Capacity Extension at Shannon Foynes Durnish Lands Development Stage 1 Road Safety Audit - Designers Response

Client:	Shannon Foynes Port Company		
Project Title:	Capacity Extension at Shannon Foynes Durnish Lands Development		
Document Title:	Stage 1 Road Safety Audit - Designers Response		
Document No:	IBH0548/RSADR/S1		
Text Pages:	11	Appendices:	0

Figure 3.1: Existing Priority Junction in Immediate Proximity to Proposed New Priority Junction (Source: RPS drawing Proposed Road Markings – Sheet 1 of 4, ref: H0548-RPS-XX-00-DR-HE-110-02)

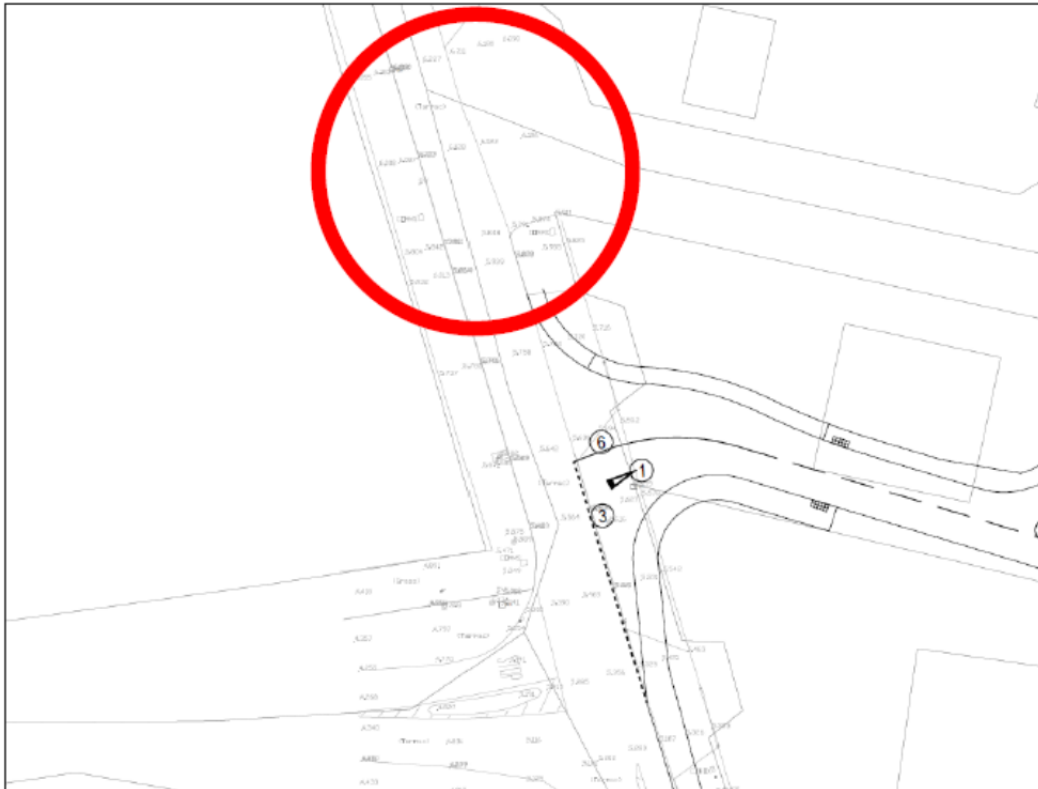
Location: *Existing junction to the immediate north of proposed new priority junction on existing main port access road.*

Summary: *Clarification on potential closely associated priority junctions*

The information provided for audit does not indicate if the existing priority junction to the north of the proposed road works on the main port access road is to be retained, and do not show tie-in details for same (junction highlighted in Figure 3.1). The proposed new priority junction to the south is in the immediate proximity of this existing junction. In the event where both junctions are incorporated into the development, this presents a potential risk that traffic may emerge from either junction without appropriate knowledge of traffic at the other intersection. Such closely spaced intersections also present a potential risk of road users incorrectly interpreting the road layout in this area and / or inappropriately indicating the intended direction of travel and coming into conflict.

Recommendation

It is recommended that the design team clarifies the proposed nature and configuration of the existing junction to the north of the proposed new priority junction, and how it is to be incorporated into the wider scheme. It is further recommended that the design team considers closing this existing access to vehicular traffic.

General comment: A preliminary design was prepared for the Stage 1 Audit. As with other elements of the design, this will be developed at detailed design stage at which time it can be assessed as part of a Stage 2 Road Safety Audit.

The design team can confirm that the existing junction to the immediate north of the proposed middle access road will be closed up to vehicular traffic and replaced by the proposed middle access road.

Figure RPS3.1: Roundabout Vehicle Tracking

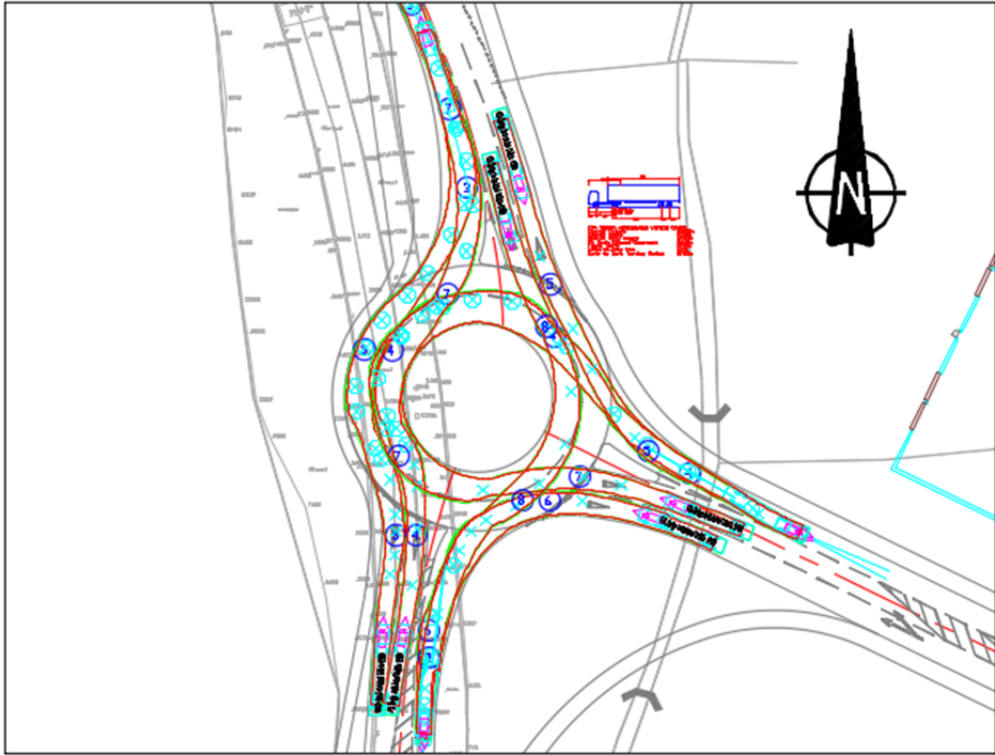
Location: *Throughout the extents of the proposals*

Summary: *HGV movements at junctions throughout the extents of the proposals*

It is unclear from the information provided for audit if large vehicles such as HGVs can manoeuvre through the proposed roundabout junction and priority junctions throughout the scheme within the confines of the carriageway. This presents a potential risk of other road users, particularly non-motorised users, being struck by passing vehicles, including trailers of HGVs.

Recommendation

It is recommended that the design team ensures appropriate swept path analyses are completed to ensure that the anticipated vehicle types and vehicle speeds can be safely accommodated by the proposed roundabout junction and priority junctions throughout the scheme within the confines of the carriageway, and adjust the carriageway alignment, if required.

It is further recommended that the design team ensures the proposed junctions throughout the scheme are appropriate in terms of scale, junction radii and general configuration to safely accommodate the anticipated HGV traffic in the port

All junctions have been designed to facilitate HGV movements. Typically all junctions have been provided with 15m radii with a 1:6 taper on approach and exist from the junction in accordance with DMRB standards. Vehicle tracking of the roundabout and middle access junction has been provided in Figure RPS3.1 & RPS3.2 below. Notwithstanding this, all junctions are located within private lands.

Figure RPS3.2: Middle Access Junction

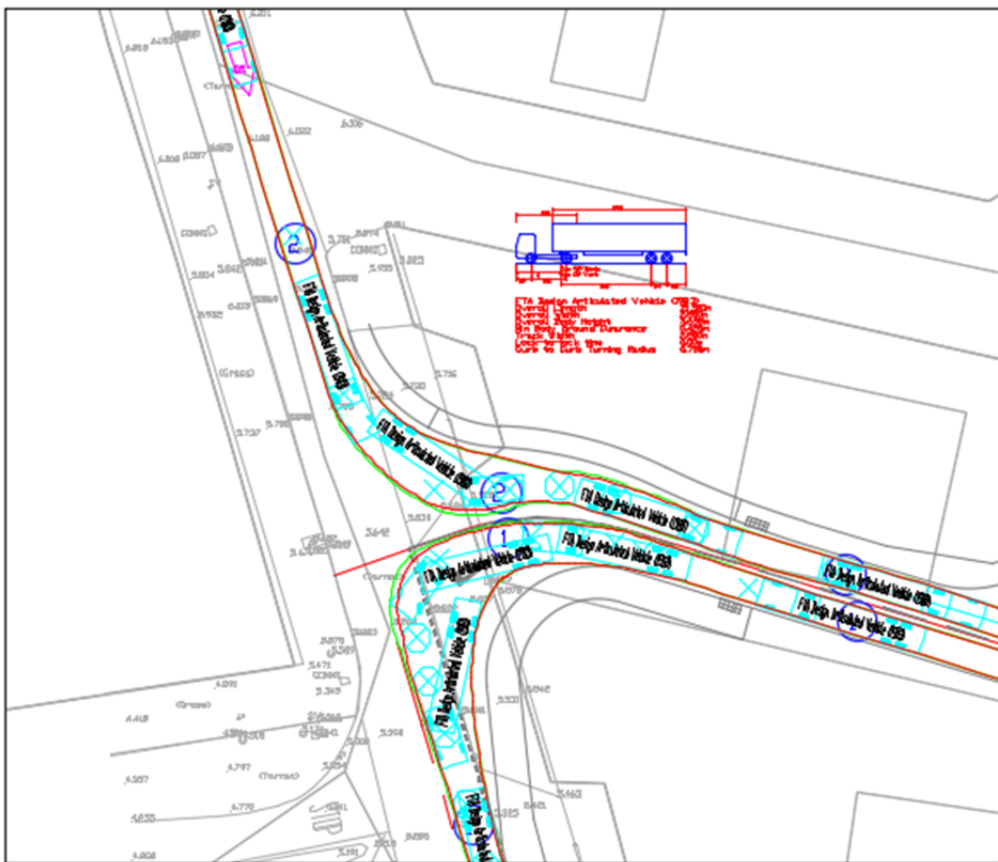
Location: Proposed staggered junction arrangement on main port access road

Summary: HGV movements at proposed staggered junction arrangement

The drawings provided for audit show the proposed new priority junction with the main port access road to be staggered from the existing junction to the south (junctions highlighted in Figure 3.2). It is unclear how the existing junction is to be tied into the wider scheme. It is also unclear from the information provided if large vehicles such as HGVs can manoeuvre between these junctions, particularly if travelling from east to west, within the confines of

the carriageway. This presents a potential risk of other road users, particularly non-motorised users, being struck by passing vehicles, including trailers of HGVs.

Recommendation

It is recommended that the design team clarifies the proposed nature and configuration of the existing junction to the south of the proposed new priority junction, and how it is to be incorporated into the wider scheme.

It is further recommended that the design team ensures appropriate swept path analyses are completed to ensure that the anticipated vehicle types and vehicle speeds can be safely accommodated by the proposed junction arrangement within the confines of the carriageway, and adjust the carriageway alignment, if required.

It is acknowledged that the two junction intersections are spaced closely together however these junction intersections are considered to be lightly trafficked and are private roads, i.e. located within the private and secure Port owned and operated lands inside the control barrier to the port. Any traffic movement / operational issues will be managed by port staff and therefore the risk of road users incorrectly interpreting the road layout in

this area and / or inappropriately indicating the intended direction of travel and coming into conflict is not considered to be significant.

Please refer to the vehicle tracking provided in the response to Item 3.1.4.

Figure 3.3: Proposed Uncontrolled Pedestrian Crossing in Vicinity of New Priority Junction on Main Port Access Road (Source: RPS drawing Proposed Road Markings – Sheet 1 of 4, ref: H0548-RPS-XX-00-DR-HE-110-02)

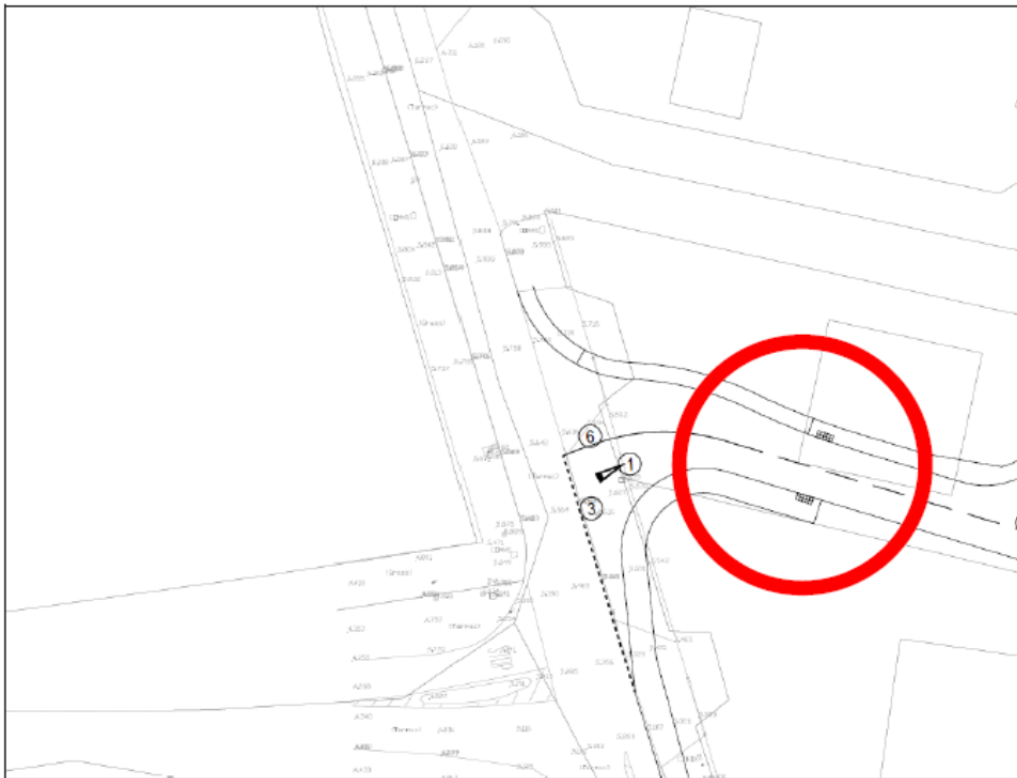
Location: *Proposed New Priority Junction on Main Port Access Road*

Summary: *Proposed Pedestrian Crossing Outside Desire Lines*

The pedestrian crossing located close to the proposed new priority junction on the main port access road (see Figure 3.3) appears to be well outside pedestrian desire lines for the majority of users and will potentially not be used by most pedestrians. This may potentially result in pedestrians or other non-motorised users crossing the carriageway at inappropriate locations and coming into conflict with passing traffic.

Recommendation

It is recommended that the design team ensures that there is appropriate continuity of pedestrian facilities at this junction along pedestrian desire lines.

There is no footway on the existing port access road to the north of the proposed middle access junction, please see Figure RPS3.3 below which illustrates the footway and verge provision in this locality. There is therefore no pedestrian desire line which would result in pedestrians or other non-motorised users crossing the carriageway at this point.

The pedestrian crossing which is to be provided as shown crossing shown in Fig 3.3 is intended for pedestrians and non-motorised users travelling along the proposed footway from the roundabout and with a desire to access the Durnish Lands development.
